<u>ENGINE - FUEL AND CONTROL - REPLACE THE FUEL DIVERTER AND RETURN VALVE PACKINGS WITH PACKINGS MADE FROM IMPROVED MATERIAL - CATEGORY CODE 6 - MOD.ENG-73-0062</u>

V2500-ENG-73-0062

No. 13298-73-005

ENGINE - FUEL AND CONTROL - NEW FUEL DIVERTER AND RETURN VALVE ASSEMBLY WITH CHANGING MATERIAL OF PACKING

Reidentification of Fuel Diverter and Return Valve Figure 1

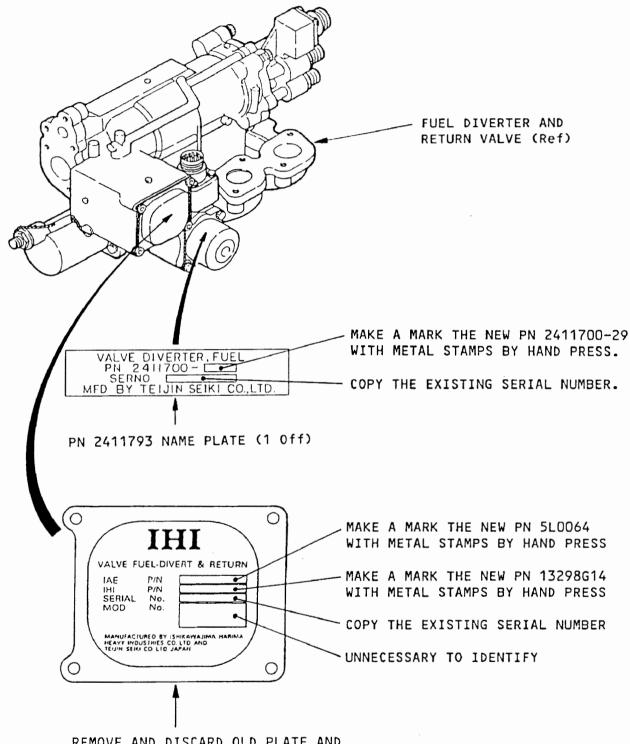
(c) Make a mark the new part number on the new 13713P1, name plate and identify as follows; Use the metal stamps by hand press (Refer to Figure 1).

(IAE P/N) 5L0064 (IHI P/N) 13298G14

- (d) Assemble the FDRV and install the name plate by the approved procedures in Reference (2), Assembly.
- (e) Make a mark the new part number adjacent to old part number on the 2411793, existing name plate and identify as follows (Refer to Figure 1):

(Teijin Seiki P/N 2411700-29)

REMOVE AND DISCARD OLD PLATE AND INSTALL THE NEW PN 13713P1 NAME PLATE (1 off)

Reidentification of Fuel Diverter and Return Valve Figure 1

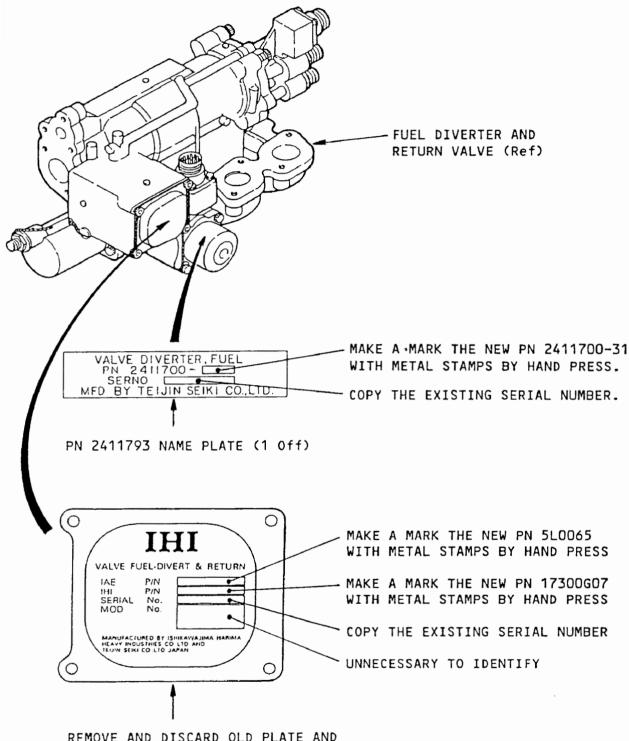
(c) Make a mark the new part number on the new 13713P1, name plate and identify as follows;
Use the metal stamps by hand press (Refer to Figure 1).

IAE P/N 5L0065 IHI P/N 17300G07

- (d) Assemble the FDRV and installation of the name plate by the approved procedures in Reference (2), Assembly.
- (e) Make a mark the new part number adjacent to old part number on the new 2411793, existing name plate and identify as follows (Refer to Figure 1):

(Teijin Seiki P/N 2411700-31)

REMOVE AND DISCARD OLD PLATE AND INSTALL THE NEW PN 13713P1 NAME PLATE (1 off)
